NOTICE OF MEETING

TO: Planning Commission
FROM: Emily Becker, Planning Director
AGENDA ITEM: Boulder Ponds 4th Addition Final Plat and Planned Unit Development (PUD) Plans
REVIEWED BY: Jack Griffin, City Engineer

Request: Final Plat and PUD Plans for Boulder Ponds 4th Addition to congregate housing with accessory services

**Re: PLANNED UNIT DEVELOPMENT (PUD) & FINAL PLAT APPLICATIONS for a
SENIOR ASSISTED LIVING & MEMORY CARE APARTMENT DEVELOPMENT**

1 SITE LANDSCAPE PLAN
L1

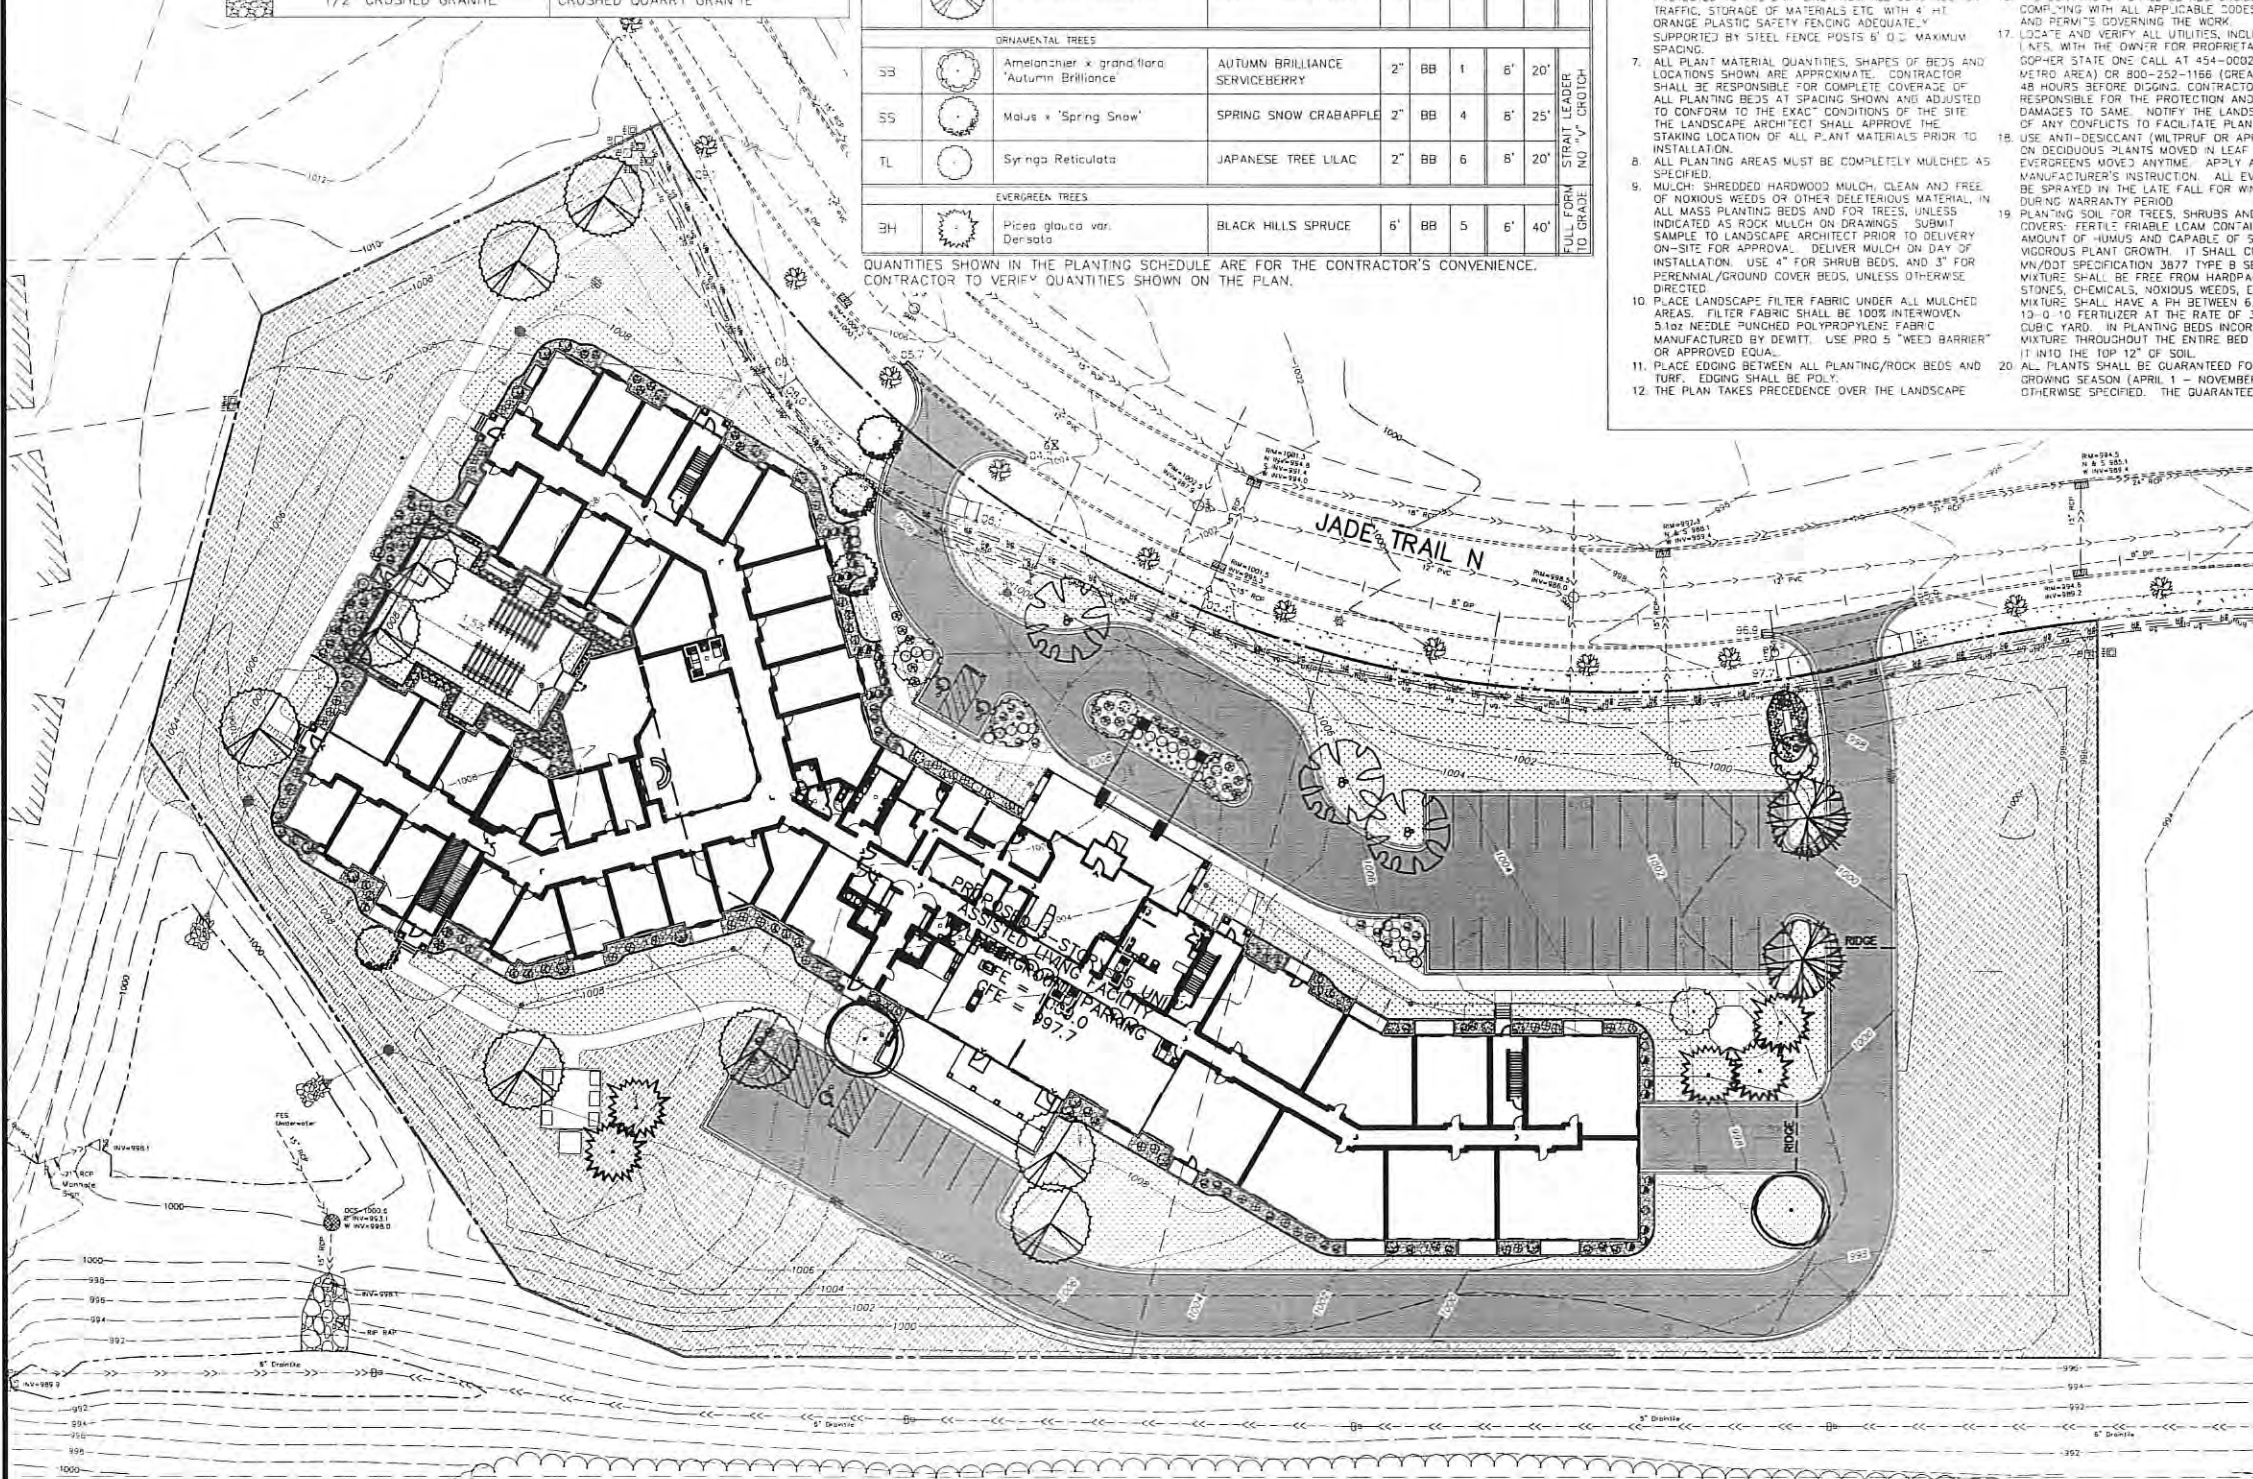
Boulder Ponds Senior Housing Landscape Plan. Only five trees proposed along northern property lines. Recommended condition that there be at least one deciduous or coniferous tree every 40 feet.

- *Perimeter Parking Lot Landscaping.*
 - *Frontage Strip.* A well-over five-foot wide frontage strip is provided between the parking area and street. Screening has not been provided along Jade Trail, and it is a recommended condition of approval that this be provided. A masonry wall, fence, berm or hedge or combination that forms a screen a minimum of three and a half and a maximum of four feet in height and not less than 50% opaque on a year-round basis should be provided. The requirement that at least one deciduous tree be planted every 50 linear feet has been met along Jade Trail with the existing trees that were planted with the development of Boulder Ponds.

- 8) Landscape plans must be approved by the City's Landscape Architect prior to recording of the final plat. The landscape plans must meet all city screening requirements including screening on the northern portion of the property to include a masonry wall or fence in combination with landscape material that forms a screen at least six feet in height and not less than 90% opaque and a minimum of one deciduous or coniferous tree at least every 40 feet, as well as perimeter parking lot screening along Jade Trail North in the form either a masonry wall, fence, berm, or hedge or combination that forms a screen three and one-half to four feet in height and not less than 50% opaque on a year-round basis.

LAKE ELMO LANDSCAPE CODE

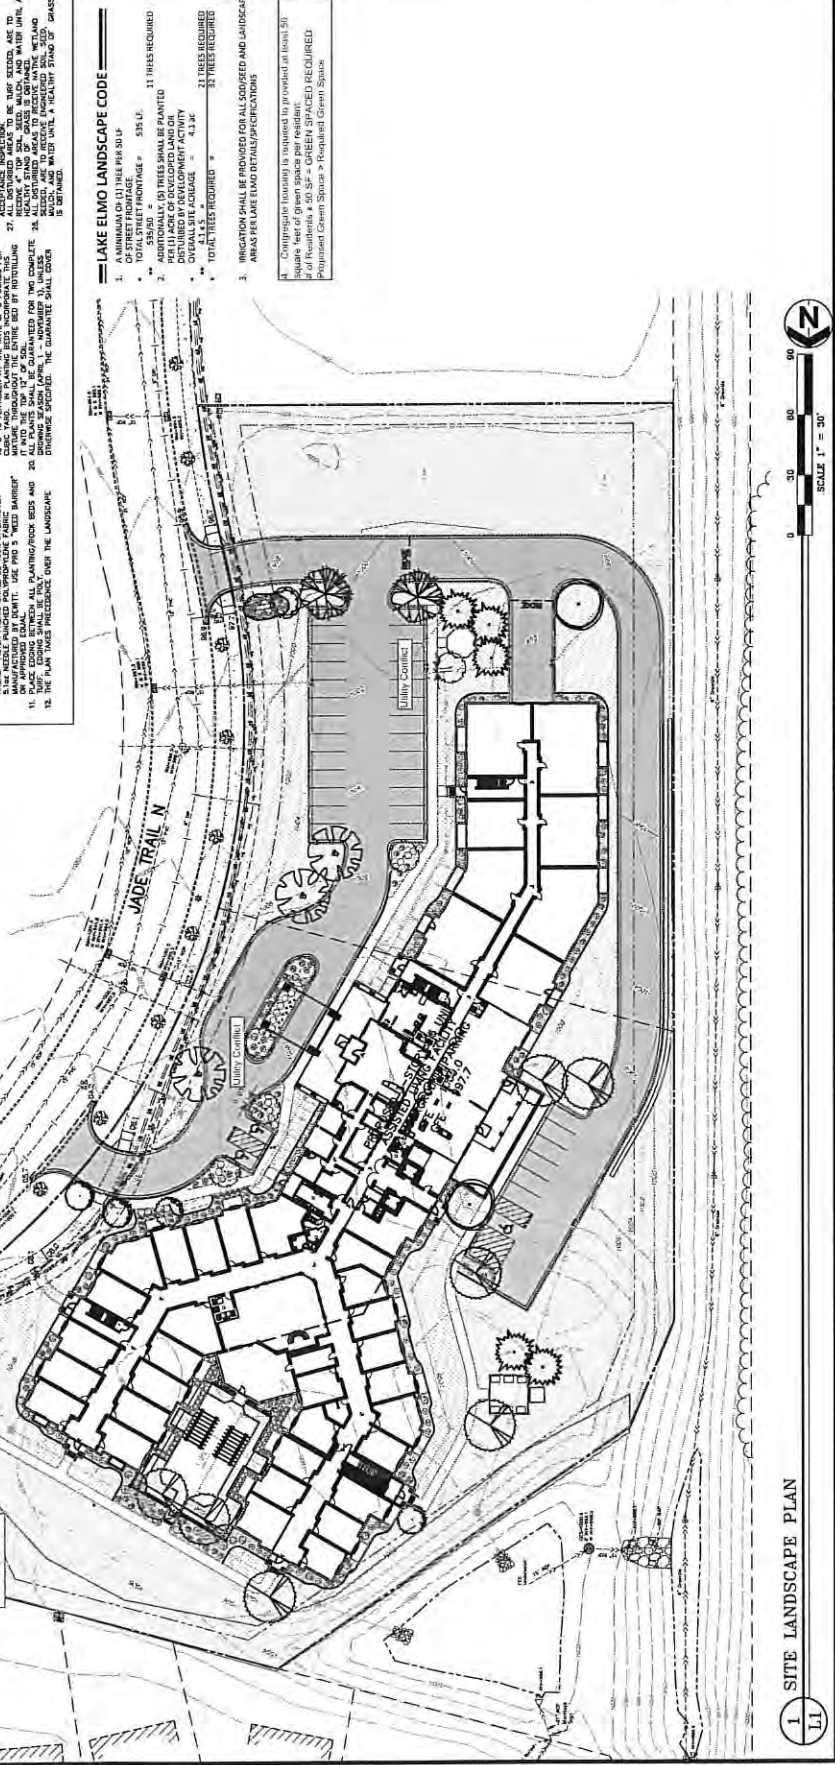
- There is single family detached housing to the north, and as shown below in the Boulder Ponds single family detached housing landscape plan, screening has not been provided in the rear yards of these lots. The attached landscape plan shows that five Northwoods Maples are proposed along the northern edge of the property. Staff believes that there should be additional screening provided along the north edge of the property that includes at least one deciduous or coniferous tree per forty feet along the three northern property lines.

- *Screening.* As previously mentioned, screening is required to provide visual and noise separation of intensive uses from less intensive uses. The property to the north is guided for and currently is used for Low Density residential. Landscaping is provided along the edges of the buildings, but a masonry wall or fence in combination with a landscape material that forms a screen at least six feet in height along with at least one deciduous or coniferous tree per 40 linear feet along the property line should be provided.

Landscape Plans. The applicant has submitted landscape plans which have been reviewed by the City's landscape architect. This review is attached to this memo and indicates that the proposed landscape plan does not provide at least 25% coniferous trees as required by ordinance, does not provide screening on the north end of the site, has utility conflicts, and sufficient green space as required by ordinance.
